# **SCOPING OPINION:**

## **Proposed LionLink Multi-purpose Interconnector**

**Case Reference: EN020033**

**16 April 2024**

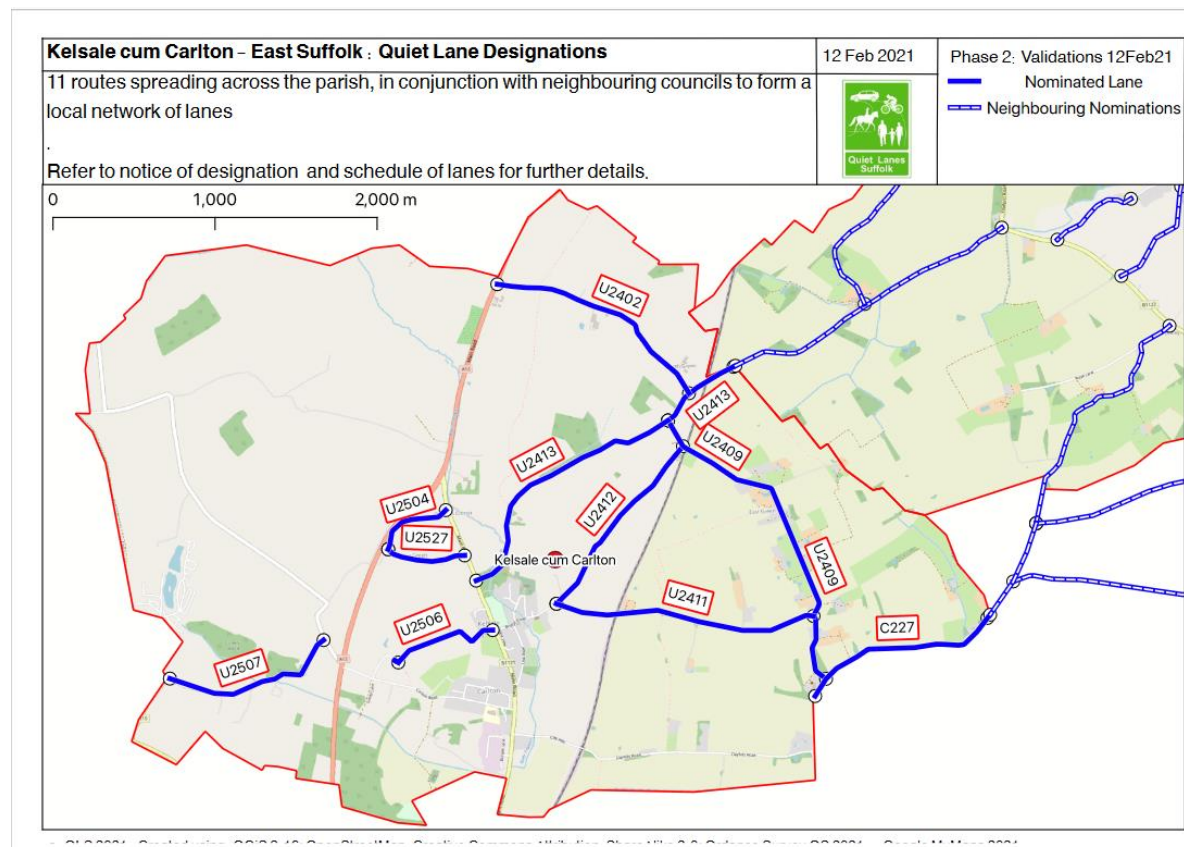
All local planning documents must be included. Much of KcC Parish is in a conservation area. See the boundary area below:

This information is missing and is necessary to further inform the EIA.

## Causeway Farm

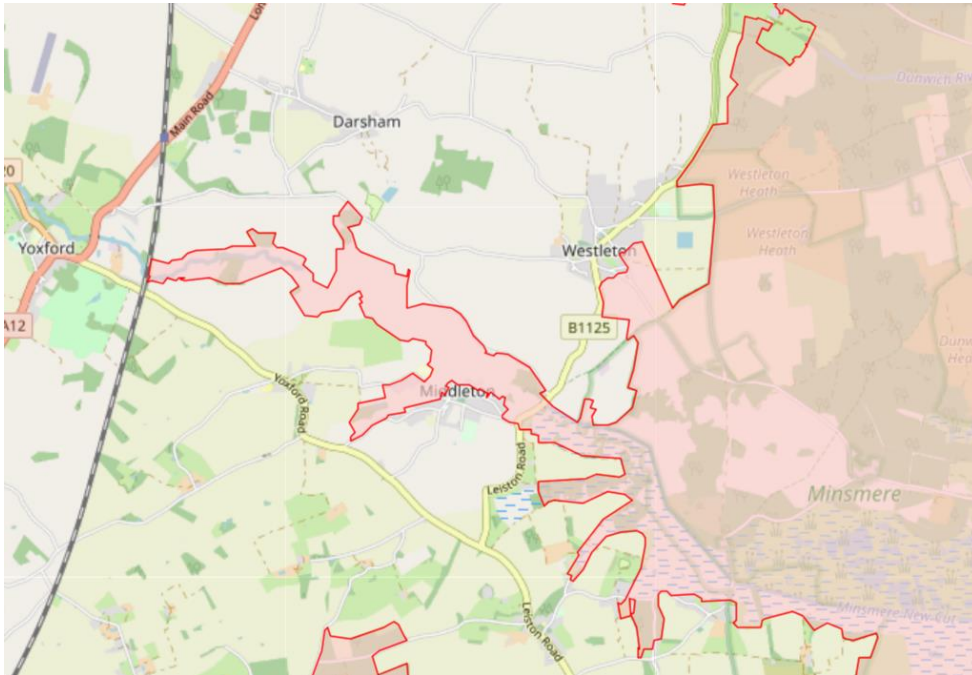
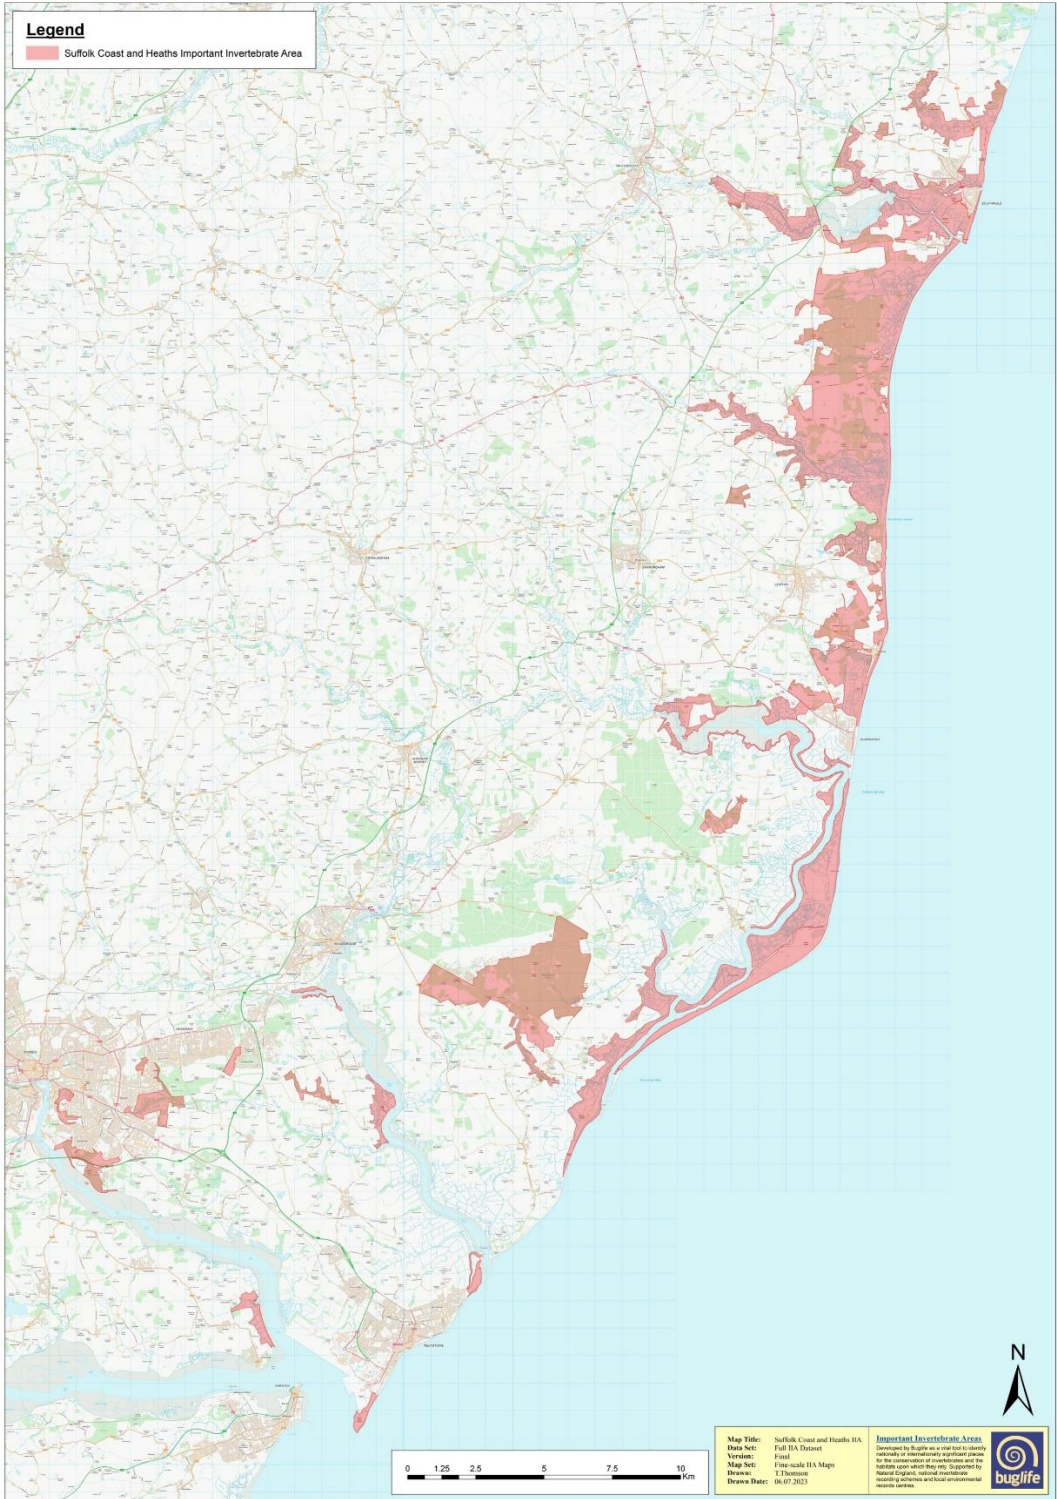
Part of the cable corridor passes through Causeway Farm which is a Suffolk County Council County Farm. This property is about to undergo changes as a result of the ending of the existing tenancy in October 2024. SCC is consulting MPC on the future of this land and the MPC is planning to request that additional (permissive) footpaths be provided to improve opportunities for exercise and access to green spaces, including the Minsmere River Valley. It is also possible that the land may be developed in other ways.

We therefore request that the scope of the EIA be expanded to include an assessment of the impact of potential land use changes at Causeway Farm.

20.40. 16.3 Baseline conditions: Fig 16-2 Recreational & community receptors DRW no LL-ARP-FIG-ECO-0010-P02 and 16.3.23 Promoted recreational routes.

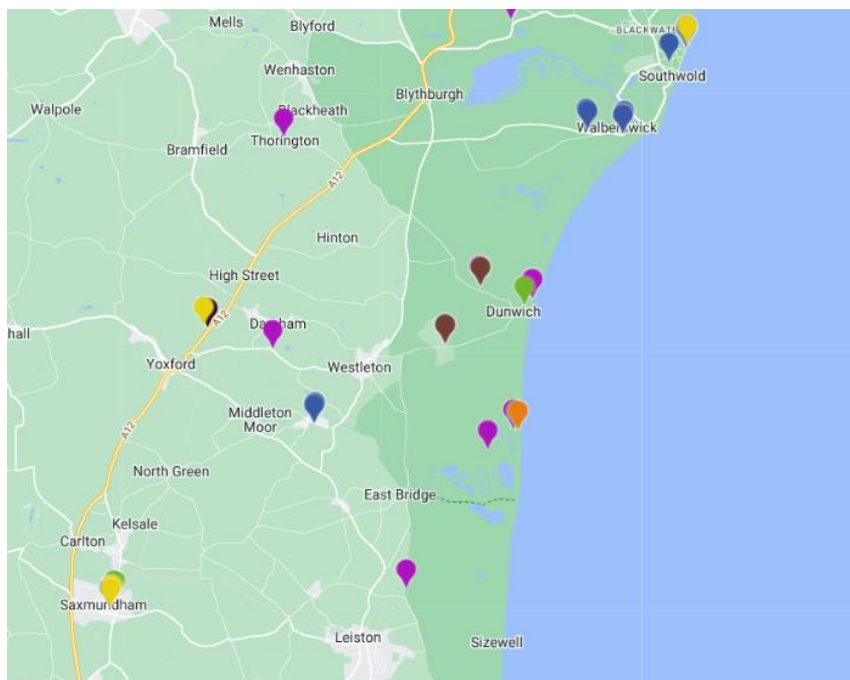
20.41. The recreational and community receptors are described as community facilities and open space, visitor attractions and promoted recreational routes.

20.42. SCC consider that the public rights of way network should itself be considered a visitor attraction as they play a vitally important part in the offer and function of the visitor economy enabling access to the countryside and wildlife of the Suffolk coast area.
